APPLICANT RESPONSE 10-14-21

Date: September 29, 2021
To: City of Austin Design Commission
From: Planning & Urban Design Working Group
Subject: Density Bonus Working Group review of 415 Colorado Street for substantial compliance with the Urban Design Guidelines

The project location is located at 415 Colorado Street.

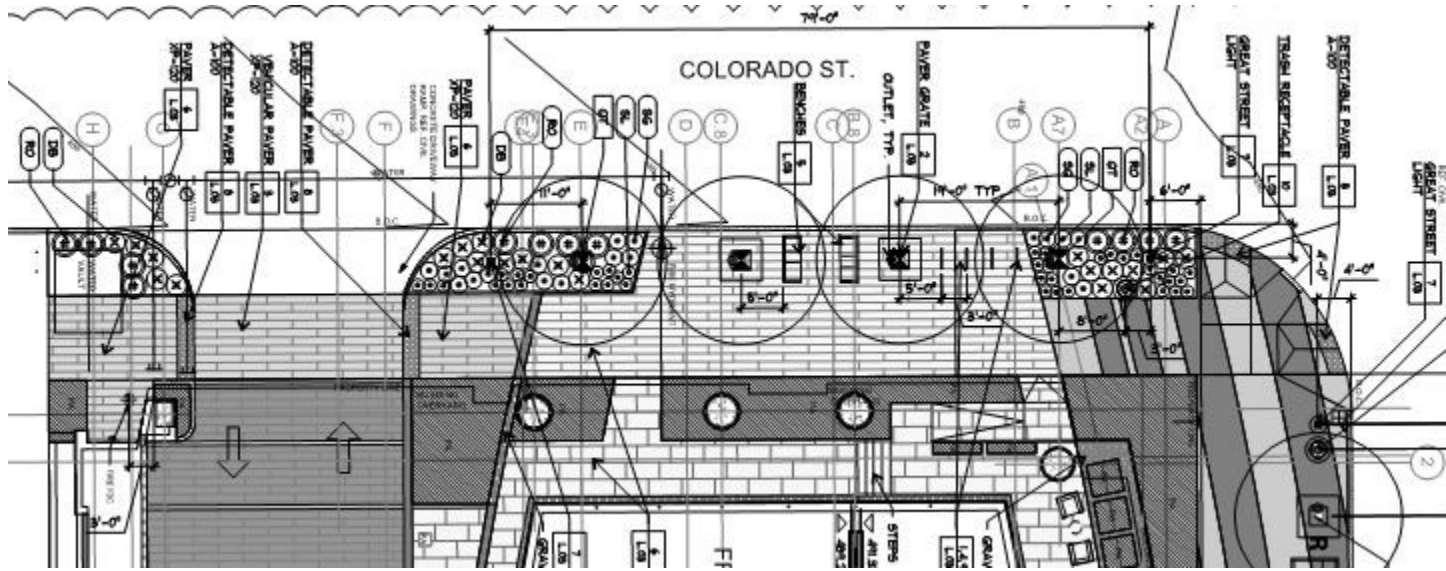
4. **Reinforce pedestrian activity-**
Beyond implementing the minimum required Great Streets components and a public art piece on the street corner, not enough emphasis is given to reinforcing pedestrian activity at the streetscape for the general public (community benefit). When the office/residential lobbies close for the day, this building, on a vital street corner, will be a dead-zone for the general public who frequent the area after business hours. Therefore, some retail component (especially food oriented), would benefit the general public as well as the office/residential tenants of the building. Project does not comply with this Section.

5. The project further reinforces pedestrian activity through the building's design and programming of the ground floor. Both residential and office lobbies are located on the ground floor and are designed to not only act as a lobby space, but also as a gathering space for residents and their guest and for office tenants and office visitors. The density of the building will add about a thousand people to this block, which will greatly increase pedestrian activity when people walk in and out of the building. Outdoor seating will also be provided.

The residential lobby will be open 24 hours and will have activity throughout the day when residents leave and return to their home. There will be increased activity in the mornings, during lunch, and in the evenings when people enter and leave the building to walk or rideshare to their workplace downtown and to local restaurants. The office lobby will be active during the day when tenants come to work, go to lunch, go home, leave for meetings, and when visitors enter and leave the building. Additional outdoor seating is provided in front of the residential and the office lobby. This seating exceeds Great Streets requirements;
